REFERENCE. C.N.260.1998.TREATIES-65 (Depositary Notification)

AMENDMENTS PROPOSED TO REGULATION NO. 16

**DRAFT SUPPLEMENT 8 TO THE 04 SERIES OF AMENDMENTS  
TO REGULATION No. 16**

(Safety-belts)

"Annex 2

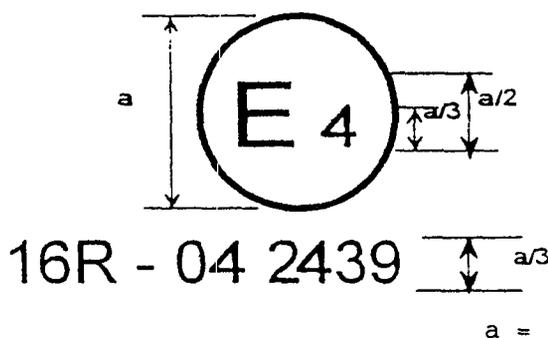
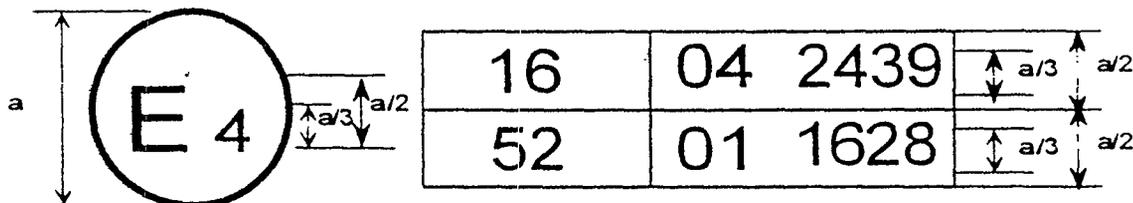
Annex 2, insert at the beginning of the annex the following paragraph 1 (including models A and B of the approval marks):

1. Arrangements of the vehicle approval marks concerning the installation of safety-belts

Model A

(See paragraph 5.2.4. of this Regulation)

The above approval mark affixed to a vehicle shows that the vehicle type concerned has, with regard to safety-belts, been approved in the Netherlands (E4) pursuant to Regulation No. 16. The approval number indicates that the approval was granted according to the requirements of Regulation No. 16 as amended by the 04 series of amendments.

Model B

(See paragraph 5.2.5. of this Regulation)

$a = 8 \text{ mm min.}$

The above approval mark affixed to a vehicle shows that the vehicle type concerned has been approved in the Netherlands (E4) pursuant to Regulations Nos. 16 and 52. <sup>1/</sup> The approval numbers indicate that, at the dates when the respective approvals were given, Regulation No. 16 included the 04 series of amendments and Regulation No. 52 the 01 series of amendments."

Annex 15 - Appendix 1

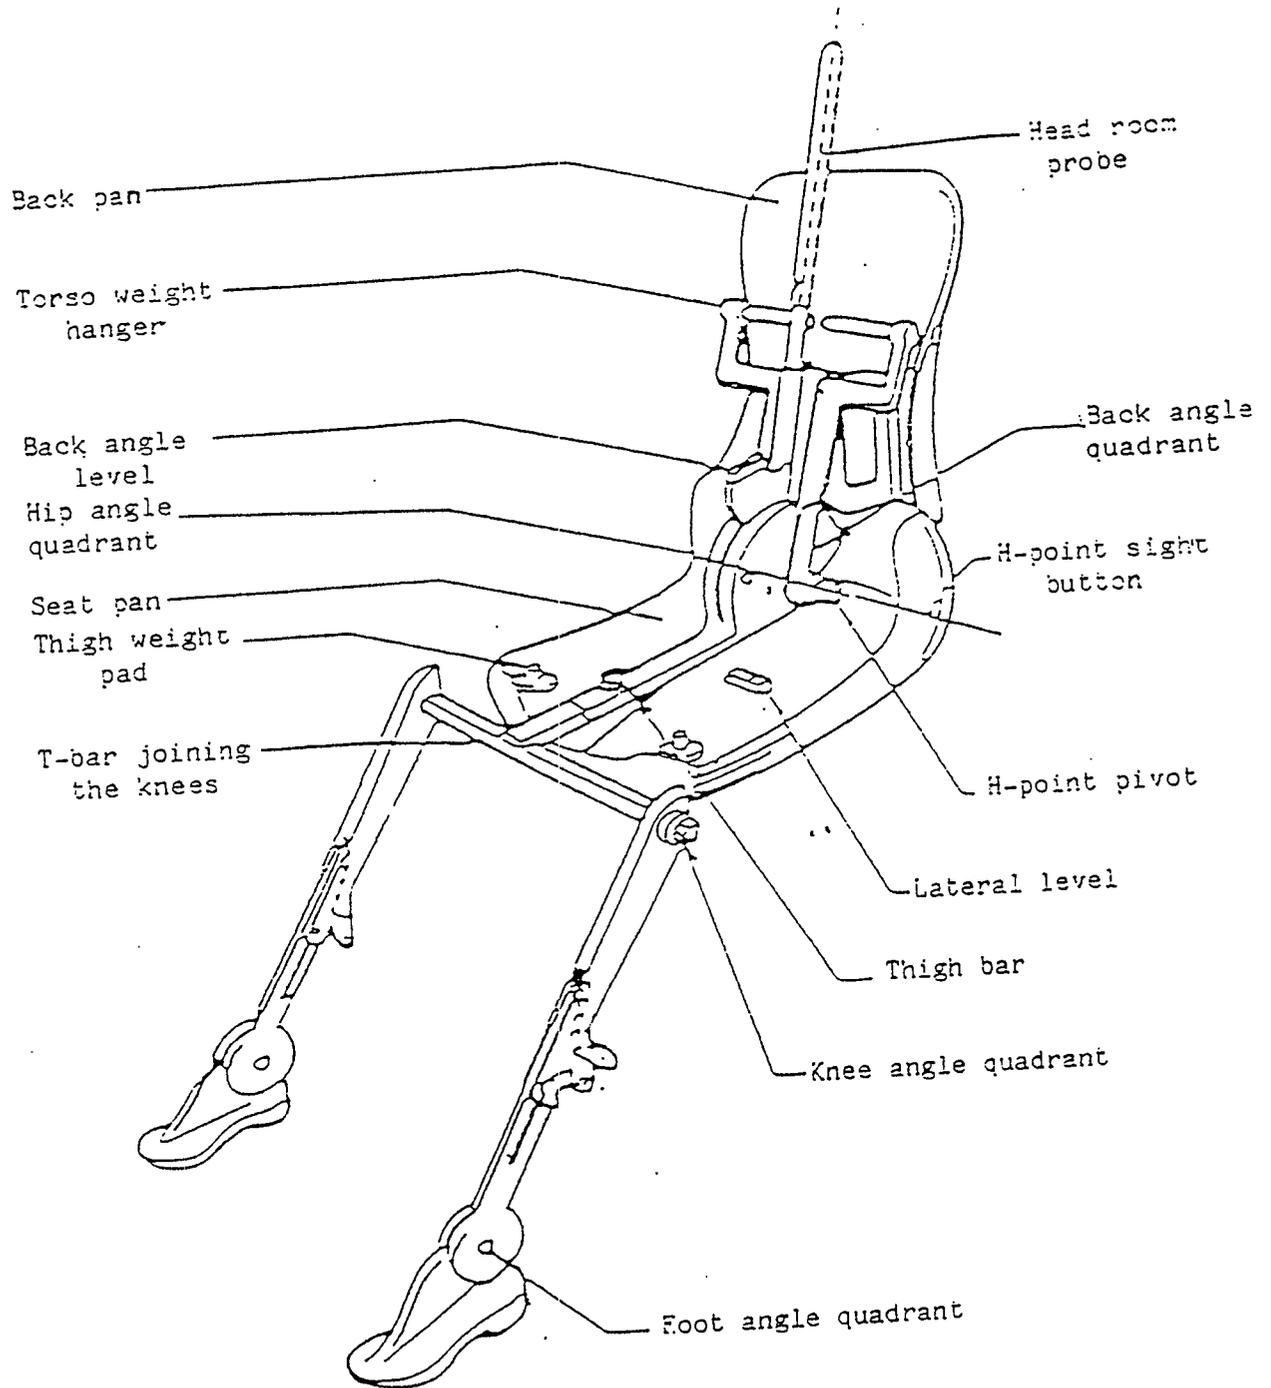
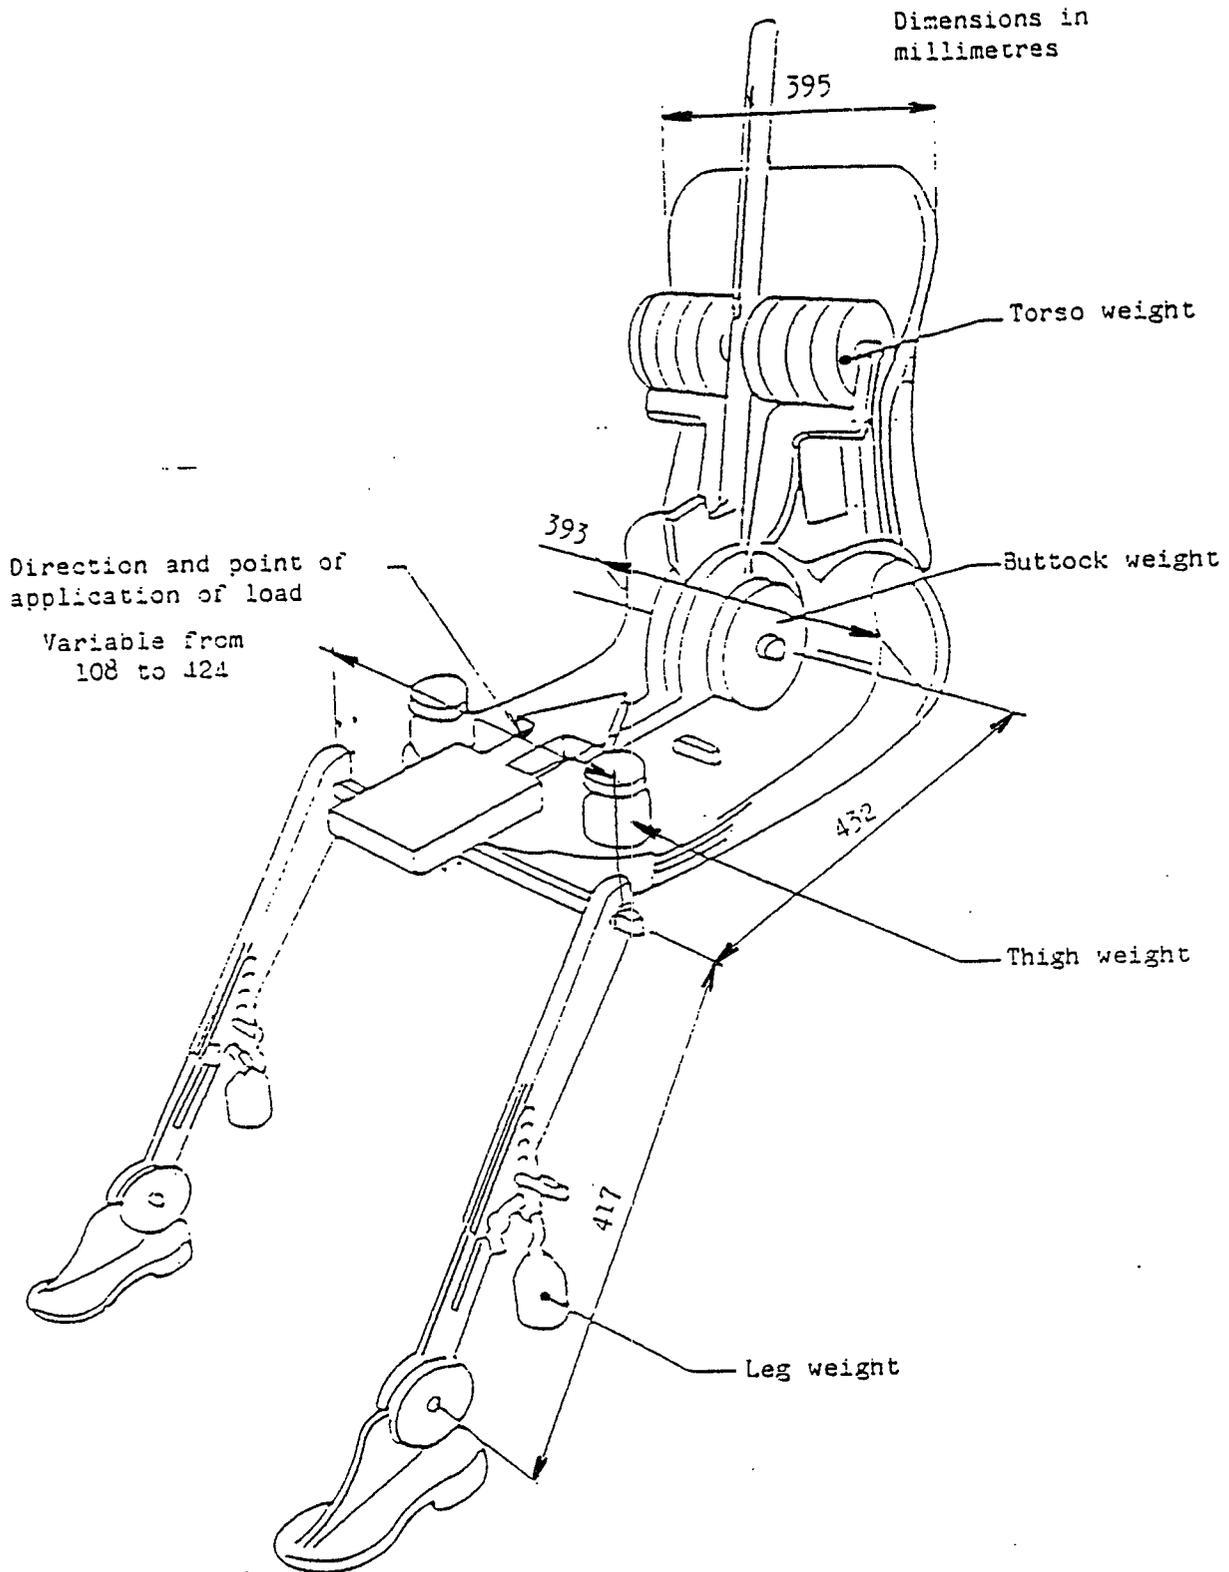
Insert a new Annex 15, to read:

Figure 1 - 3-D H machine elements designation

Figure 2 - Dimensions of the 3-D H machine elements and load distribution
